Service Bulletin

PRELIMINARY INFORMATION

Subject: BAS+ (Hybrid) eAssist MIL Battery Indicator Or Service Charging System Message On With P1EAB

Models: 2012 - 2013 Buick Lacrosse, Regal eAssist
2013 Chevrolet Malibu ECO eAssist
All with RPO HP6

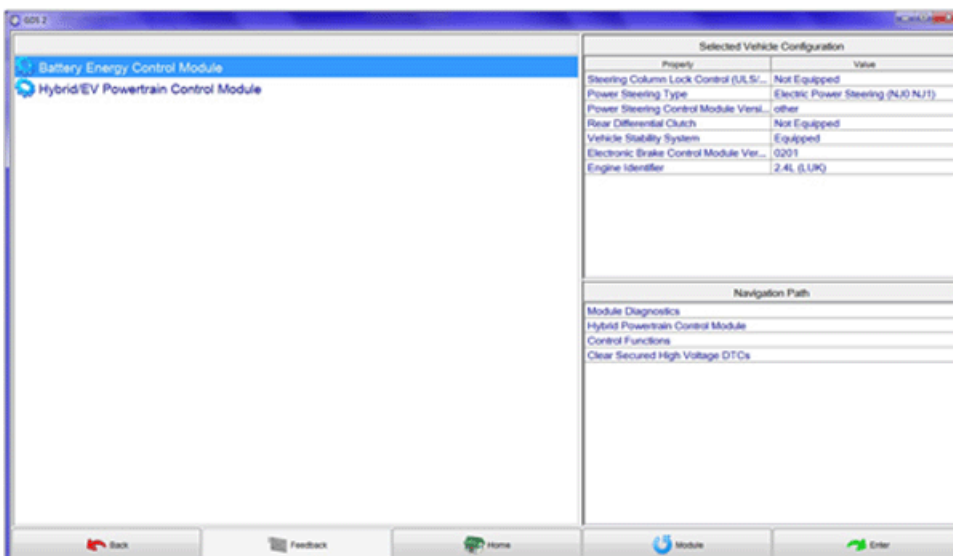
There may be a MIL, Battery Indicator or Service Charging System message on with any combination of DTCs P1EAB, P1B33, P1B34, P1B35, P1B36, P1B37, P1B38, P1B39 setting.

If G.S.I diagnostics lead to replacement of the Battery Energy Control Module (BECM), DO NOT replace the entire Powerpack or the BECM for this concern. The BECM should be SPS programmed with the latest software available for the BECM.

If the diagnostics still lead to BECM replacement, part number 20969054 has been released for service but is currently on restriction through the General Motors Technical Assistance Center (GM TAC). Once installed, the BECM will need to be SPS programmed with the latest software as shown.

Note: If P1EAB is set it will be necessary to clear the High Voltage (HV) DTC using GDS2. After selecting the proper vehicle information in GDS2 follow the Navigation Path as shown to clear the HV DTC. After the reset is selected the ignition will need to be turned off for a minimum of two minutes.

Title	Current	Revised
Operating System	22825622	22975009
Calibrations	22825621	22975008
